Access Compliance Report Public Rights-of-Way (Curb Ramps)

Main Street: NEWBURY WAY		Cross Street: FRANKLIN WAY		Location:	SW
ADA ID: RPAT211104134957	Ramp Type: Type 4 - Parallel	Initial Pass/Fail: Fail	Overall Compliance: No	Severity Score:	15

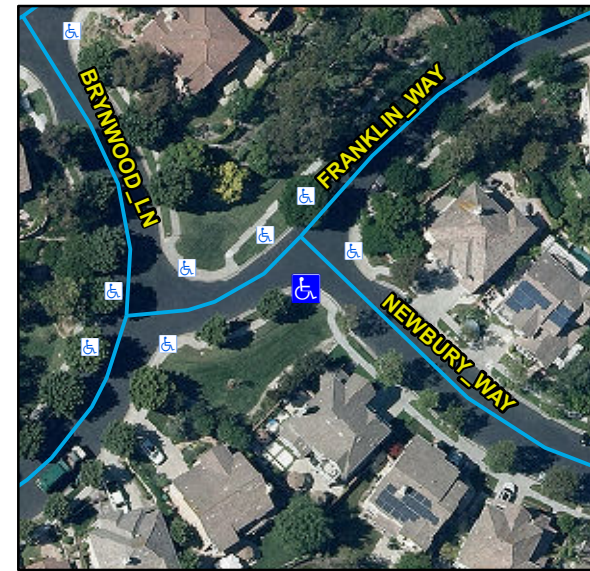
Compliance	Description	Data	Compliance	Description	Data
N/A	Ramp Length LT (in)	82	N/A	Ramp Length RT (in)	83
Yes	Ramp Width LT (in)	54	Yes	Ramp Width RT (in)	54
Yes	Ramp Run Slope LT (%)	0.3	No	Ramp Run Slope RT (%)	10.7
Yes	Ramp Cross Slope LT (%)	0.8	Yes	Ramp Cross Slope RT (%)	1.2
N/A	Landing Present	N/A	N/A	DWS Provided	N/A
N/A	Landing Length (in)	N/A	N/A	DWS Contrast	N/A
N/A	Landing Width (in)	N/A	N/A	DWS Length (in)	N/A
N/A	Landing Run Slope (%)	N/A	N/A	DWS Full Width	N/A
N/A	Landing Cross Slope (%)	N/A		DWS Offset Type	N/A
N/A	Landing Movement Obstructed?	N/A	N/A	DWS Offset Left (in)	N/A
	Landing Movement Type	N/A	N/A	DWS Offset Right (in)	N/A
N/A	Landing Shared	N/A			
N/A	Clear Space	Yes			
N/A	Clear Space To Crosswalk (in)	N/A			
N/A	Marked Crosswalk 1	No	N/A	Marked Crosswalk 2	No
	Crossing 1 Direction	NE		Crossing 2 Direction	NW
N/A	Marked Crosswalk 1 Width (in)	N/A		Marked Crosswalk 2 Width (in)	N/A

Remove & Replace Curb Ramp With Two New Directional Ramps or Equivalent.
